SERVICE BULLETIN

Service Bulletin No.: DA20-31-02 Rev 1

Title: Hourmeter, Engine Activated Installation

FIGURE 1

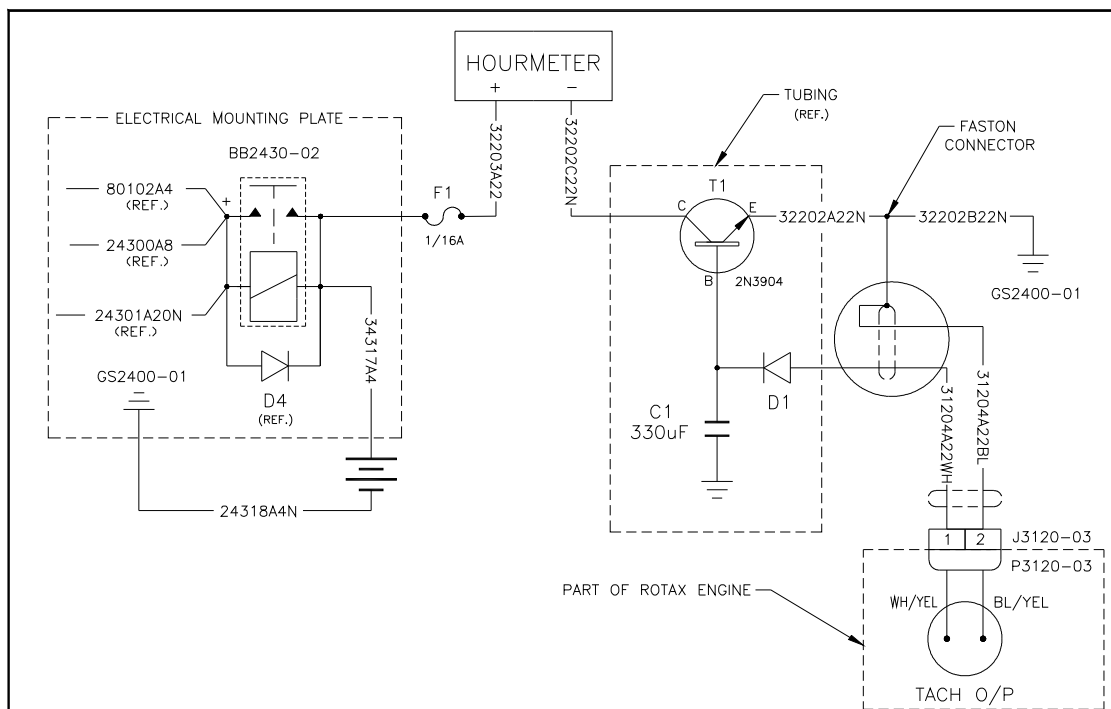
3. General: The existing Hourmeter is activated when electrical power is applied with the master switch. This new version is activated by the engine and cannot be switched off from the cockpit.

11.1.3 Disconnect wire No. 32203A22 from Hobbs Meter and Fuel Pump C/B and discard.

- 11.1.4 Disconnect wire No.32202A22N from Hobbs and plug into wire No.32202B22N and wire No.31204A22sh Faston.
- 11.1.5 Ty-Rap assembly behind gauges.
- 11.1.6 Attach wire No. 32203C22N to the Hobbs (-) Terminal and the new 32203A22 to Hobbs (+) Terminal.

- 11.1.7 Route wire No.31204A22 and wire No.32203A22 through Grommet in Firewall ty-rap as required, route through center of larger gauge wires.
- 11.1.8 Solder the fuse holder cap to the end of wire No.32203A22. Insert the fuse and close the holder.

- 11.1.9 Connect Fuse Holder Ring Terminal To the Battery Terminal on the Battery Relay.
- 11.1.10 Cut wire No.31204A22 to length, label and install connector P/N 1-480319-0 and pins P/N60617-1.

- 11.1.11 Route existing Tach wires from back of engine, label, terminate with 1-480318-0 connector and P/N 60618-1 Sockets and attach to wire No.31204A22.
